**RAI 03.07.01-27, Supplement 1, Revision 1**

**Follow-up Question to RAI 03.07.01-19 (STP-NRC-100093)**

**REVISED SUPPLEMENTAL RESPONSE:**

**RAI 03.07.01-27, Supplement 2, Revision 1**

**Figure 3H.6-225: 2D SSSI Model of DGFOT, DGFOSV and Crane Foundation Retaining Wall**

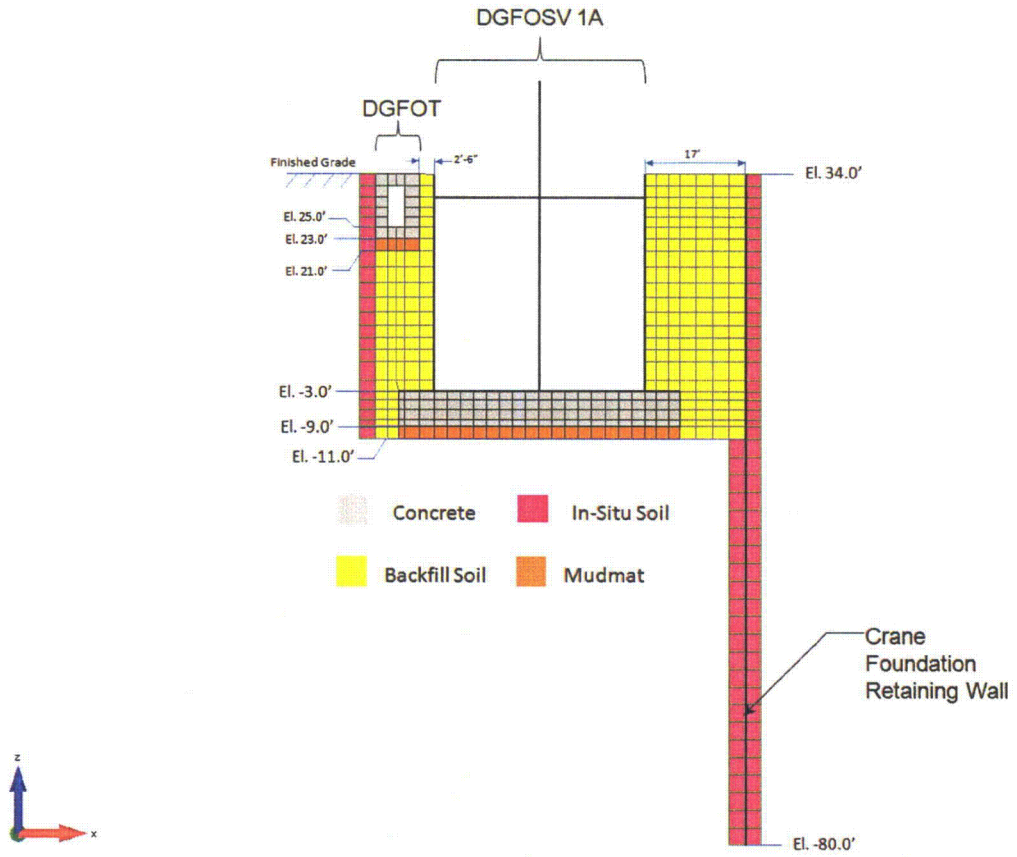
1. 10CFR50, Appendix S requires that evaluation for SSE must take into account soil-structure interaction (SSI) effects and the expected duration of vibratory motion. In the response to the first paragraph of RAI 03.07.01-19, the applicant has presented its approach for developing the input motion for the SSI analysis and design of the DGFOSV that takes into account the impact of the nearby heavy RB and RSW Pump House structures. The applicant also stated that *"Conservatively, a 3-dimensional SAP2000 response spectrum analysis was used to obtain the safe-shutdown earthquake (SSE) design forces due to structure inertia. The seismic induced dynamic soil pressure on DGFOSV walls were computed using the method of ASCE 4-98, Subsection 3.5.3.2"* The response, however, does not provide details as to how the SSI analysis of the DGFOSV are performed and how the input motion developed are subsequently specified in the SSI analysis of DGFOSV to develop the structural response and in-structure response spectra for any equipment and subsystems within DGFOSV. From the response it appears that the applicant has not included explicitly DGFOSV structural model in the SASSI model of the RB and RSW Pump House structures to properly evaluate the SSSI effect on the DGFOSV. In order for the staff to determine if the evaluation of DGFOSV for SSE has appropriately accounted SSI effects, the applicant is requested to provide in the FSAR the following information:

The second SSSI model is for a section cut in the East-West direction consisting of diesel generator fuel oil tunnel (DGFOT), DGFOSV 1A and the Crane Foundation Retaining Wall. The model for this SSSI analysis is shown in Figure 3H.6-225 (see Enclosure 1). The model details of the SSSI analysis is provided below.

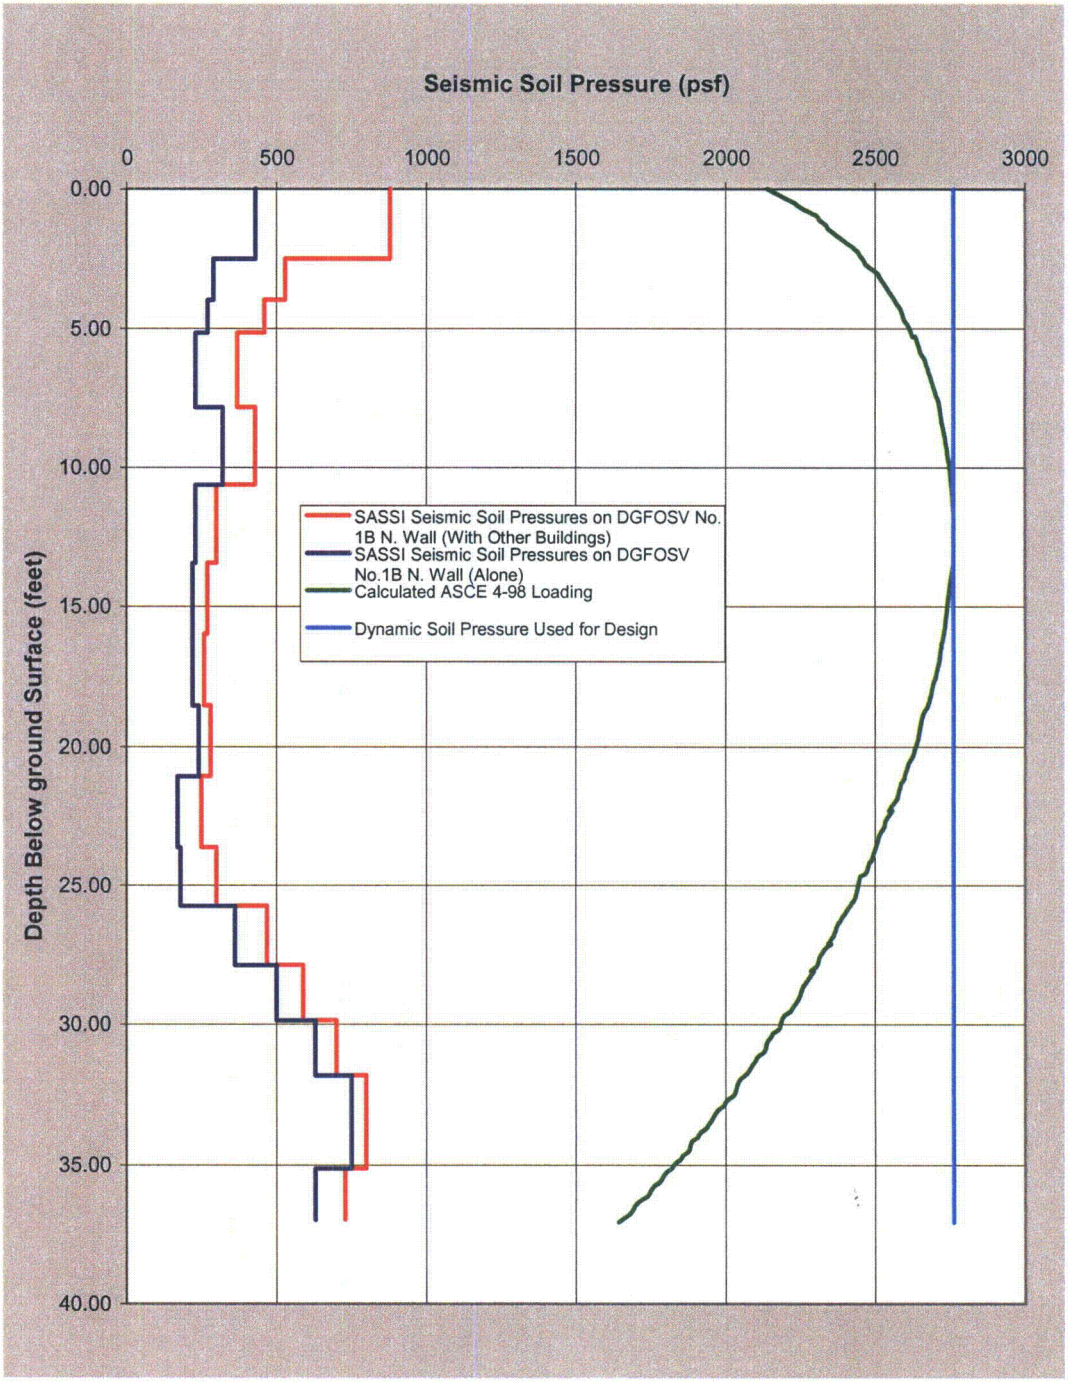
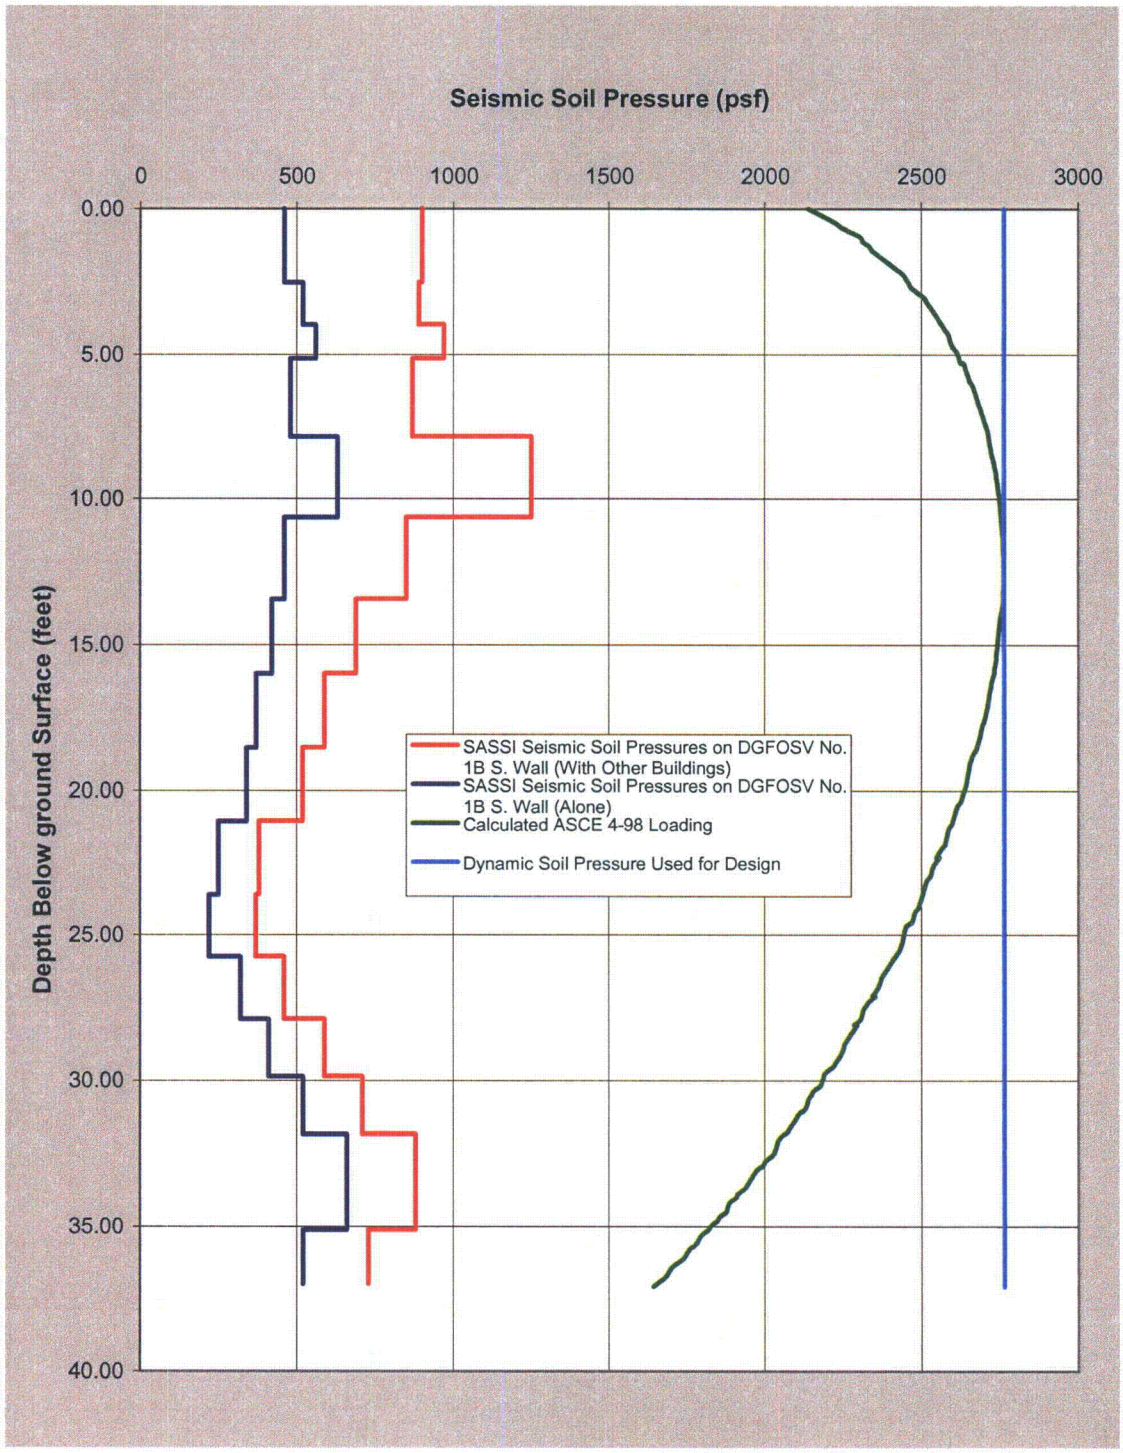
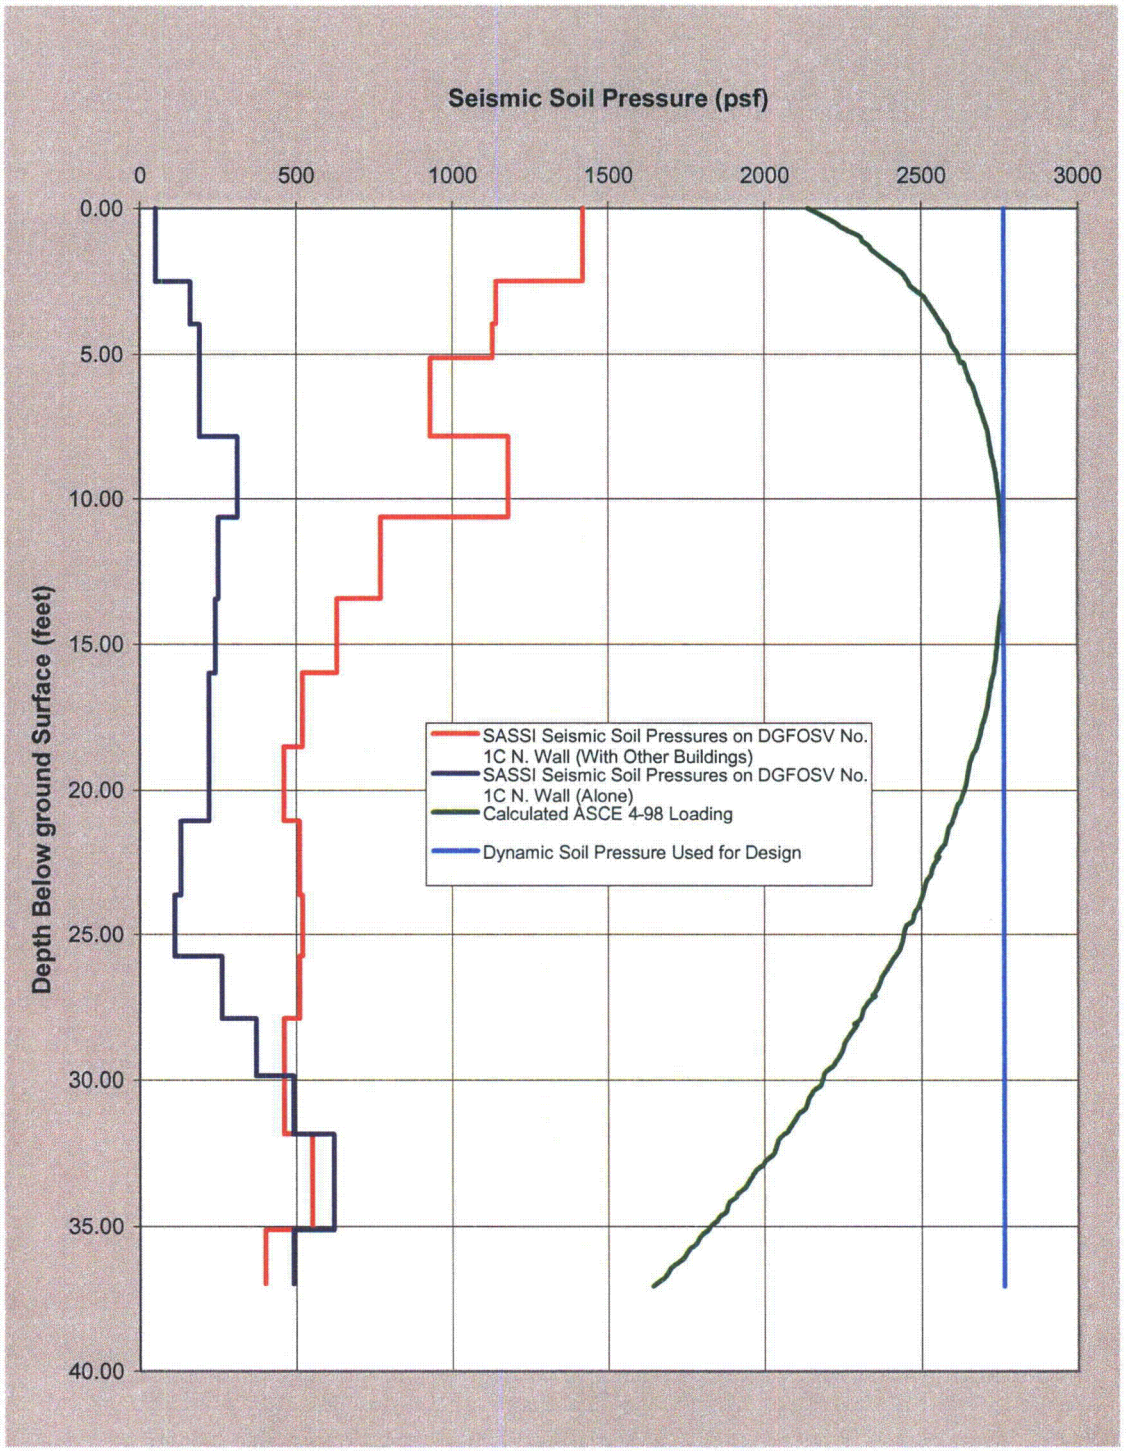
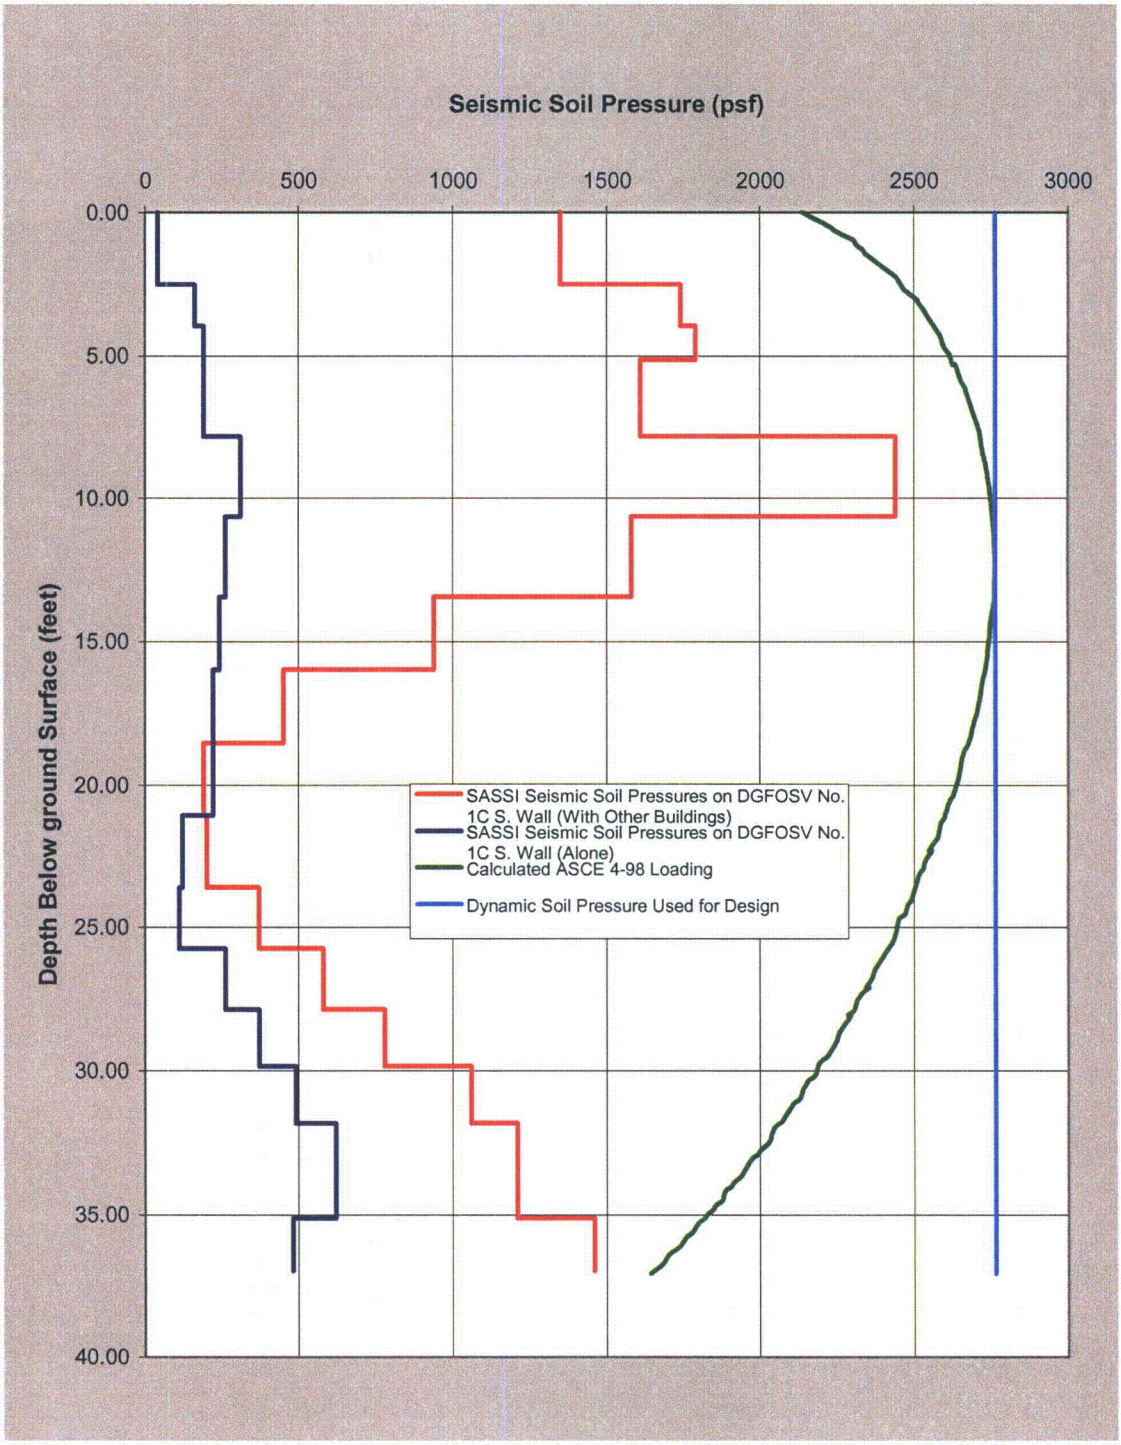
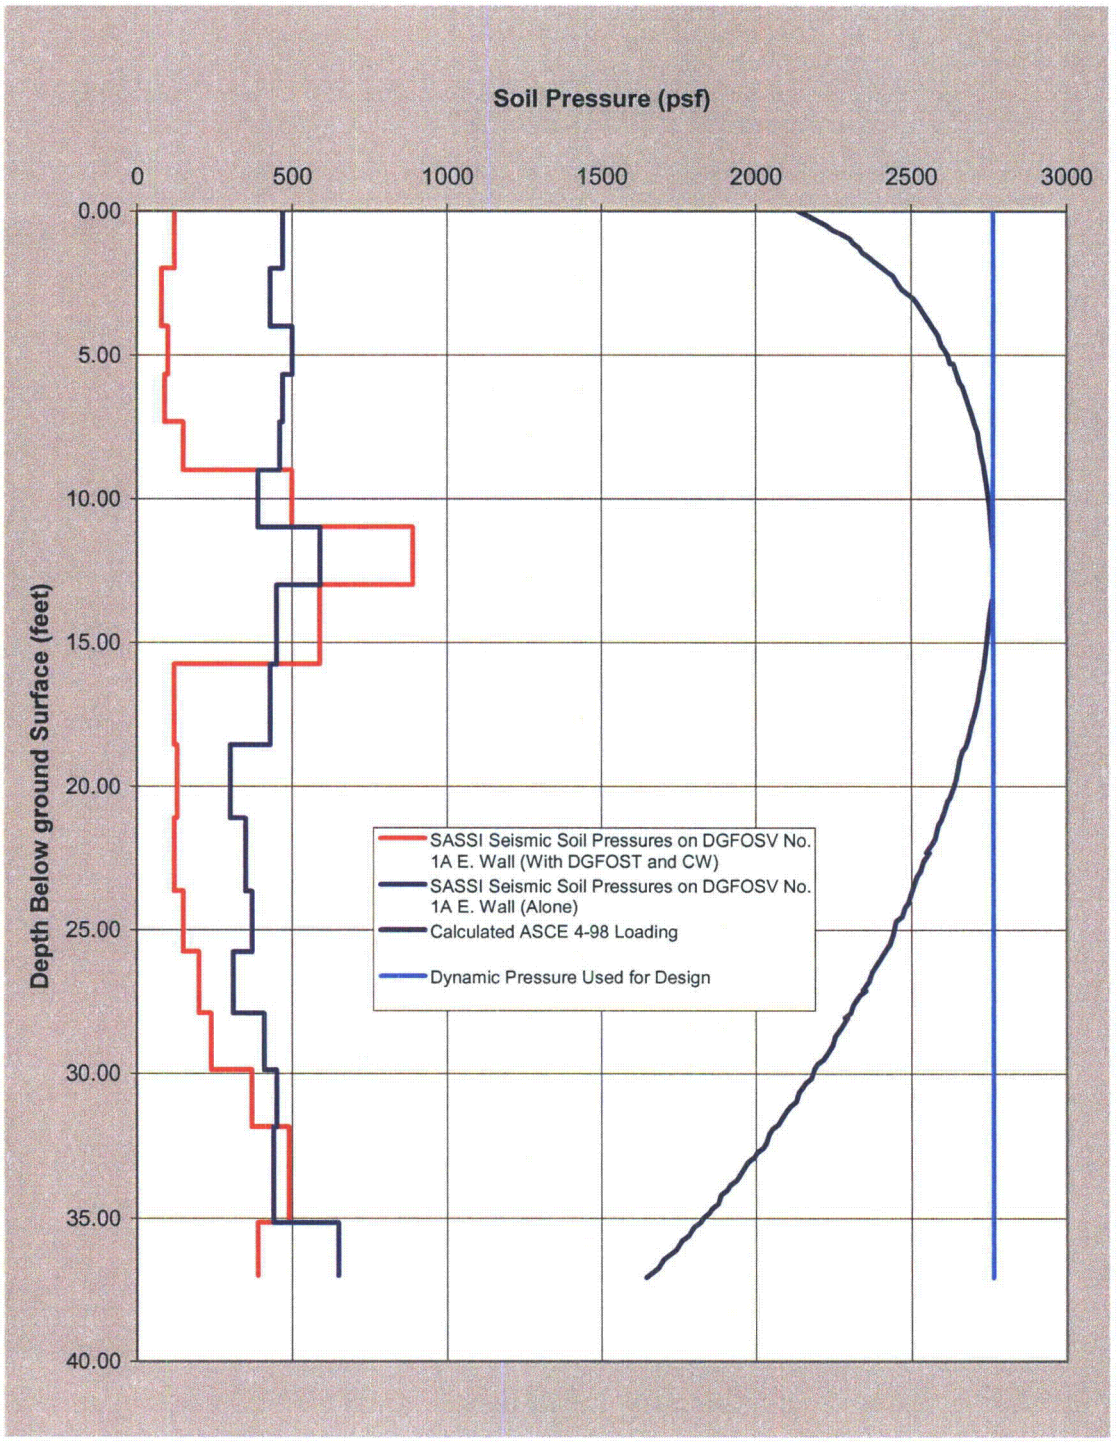
(c) Demonstrate that the DGFOSV foundation response spectra and dynamic soil pressure (on DGFOSV basement walls using ASCE 4-98 criteria) used in the design of DGFOSV will envelop the results of structure to structure (SSSI) interaction analysis which explicitly models DGFOSV structure in the SSI model of RB and the RSW Pump House structure.

1. Clarify that the seismic soil pressures in Figures 3H.6-226 to 3H.6-231 are incremental seismic soil pressures.
2. Clarify that all walls of the diesel generator fuel oil storage vaults are designed for incremental seismic soil pressures shown in Figures 3H.6-226 to 3H.6-231.
3. Clarify how the diesel generator fuel oil tank was modeled in the soil-structure interaction analyses of the diesel generator fuel oil storage vaults.

The structural analysis and design of the DGFOSV have been revised to consider incremental seismic soil pressures from the SSSI analysis described in part 1a above. Figures 3H.6-226 through 3H.6-231 show a comparison of the incremental seismic soil pressures obtained from SSSI and the ASCE 4-98 methodology and the incremental seismic soil pressure used in the design of all DGFOSV walls. The revised design results for the DGFOSV will be provided in the response to RAI 03.08.04-30, Revision 1, which is currently scheduled to be submitted by March 15, 2011.
